ROCKY MOUNTAIN ARSENAL

FINAL
TECHNICAL PLAN
VERSION 3.1

TASK NO. 10
SEWERS AND PROCESS WATER SYSTEM INVESTIGATIONS

**FIGURE 3.4-7
Investigative Program South Plants
Sanitary Sewer System**

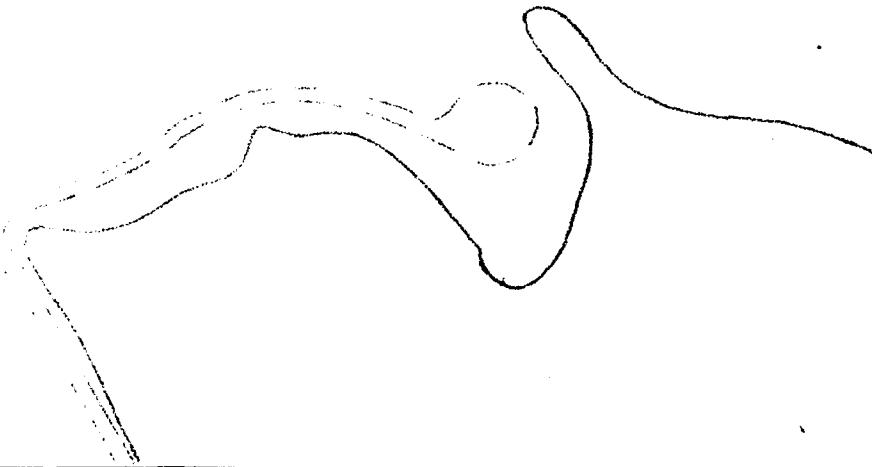
17. Comment: Page 3-29, second paragraph, and Figure 3.4-7.
The two sanitary sewer sites proposed for dye/excavation study may prove to be difficult. The site between Manholes 117B and 119B is in line with an above ground steam line that will interfere with excavation, and the site between Manholes 98 and 99 will either be below the groundwater table or very close to it.

18. Comment: Table 3.4-2, Page 3-30, and Figure 3.4-7.
The bottoms of Manholes 97, 98, 99, 100, 124 and possibly 125 have been under groundwater historically and probably are presently either below the water table or close to it. As stated on page 3-35 of the Technical Plan, Section 36 sanitary sewer manholes are not to be sampled due to the difficulty of determining the source of contamination in soils contacted by contaminated groundwater. If this is true, the same rationale should be applied to the South Plants manholes in close proximity to the contaminated groundwater mound.

**FIGURE 3.5-4
Investigative Program South Plants
Chemical Sewer System**

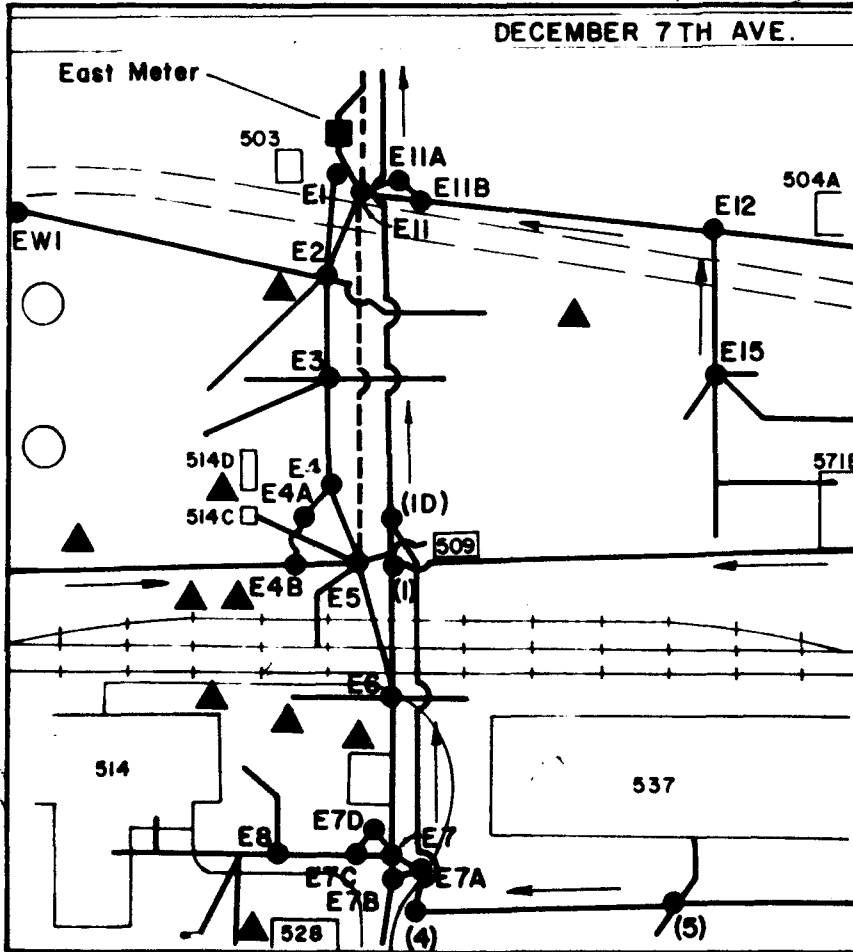
26. Comment: Page 3-47, Figure 3.5-4, and Page 3-48, Table 3.5-1. The Technical Plan proposes to investigate beneath manholes (A), (B), and (C) north of Building 732. These manholes are of precast concrete construction dated in 1953, and according to the George Donnelly, were never used. They are not representative of the significantly more numerous deteriorated contaminated sewer manholes in the South Plants and will mislead investigators if they are considered in any way "typical."

FIGURE 3.6-9

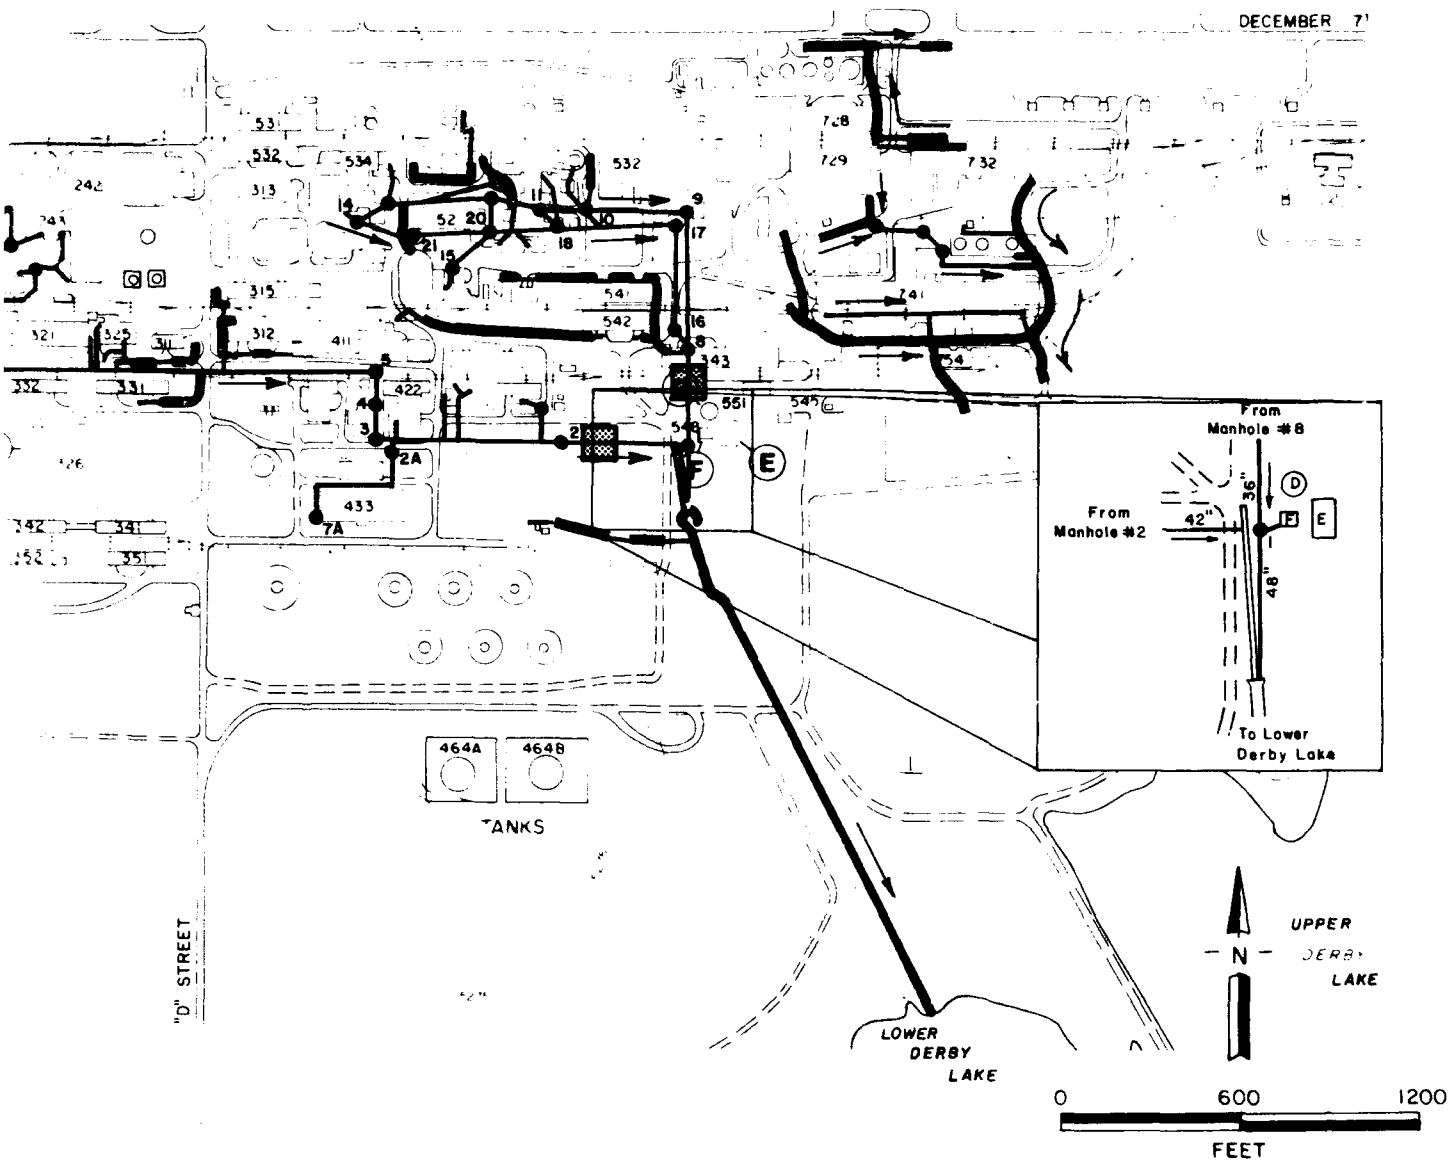
30. Comment: Page 3-61, last sentence, and Page 3-68, Figure 3.6-9.
It does not necessarily follow that contamination should be suspected in the soils underlying the process water return lines simply because water was routed through them. More importantly, however, these two large diameter lines (36 to 42 inches) are not representative of the overall system, and therefore, any leakage patterns determined by the dye method could not be considered "typical."

FIGURE 3
Investigative Program South Plants
Process Water Return System
Rocky Mountain Arsenal, Task 10
Prepared by Ebasco Services Incorporated

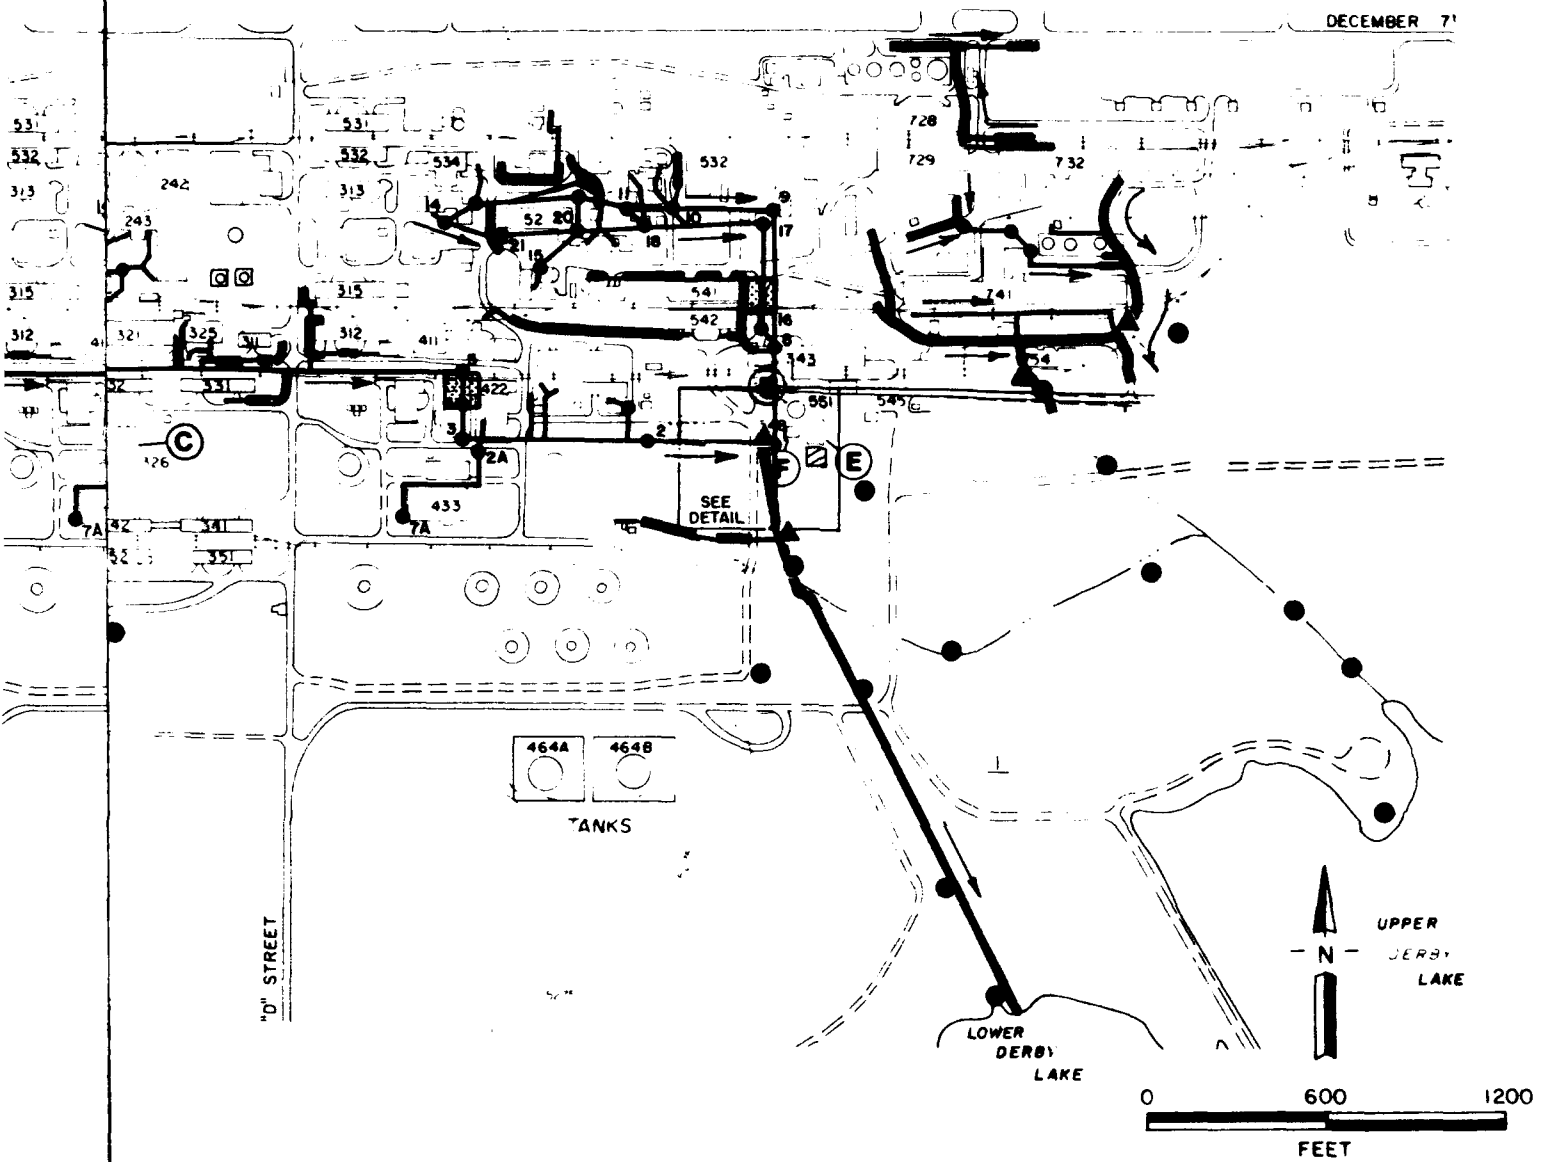
4. Comment: The proposed revision states that "after all 'worst case' situations (areas where past and present leaks overlap) have been identified during steps 1 and 2, a soil boring program will then be initiated to identify soil contamination in the areas of past and present leaks". Yet Figure 3 shows proposed boring locations for Task 10. How have these locations been determined before steps 1 and 2 have been completed?

Response: The proposed boring locations shown on Figure 3 are for the process water return system discharge points to the return ditches. These locations were chosen because these canals have, at some time, been used for returning used cooling water to the lakes storage system for recirculation. The borings to be chosen "after all 'worst cases' situations have been identified" are for the process water distribution system lines in the South Plants area.
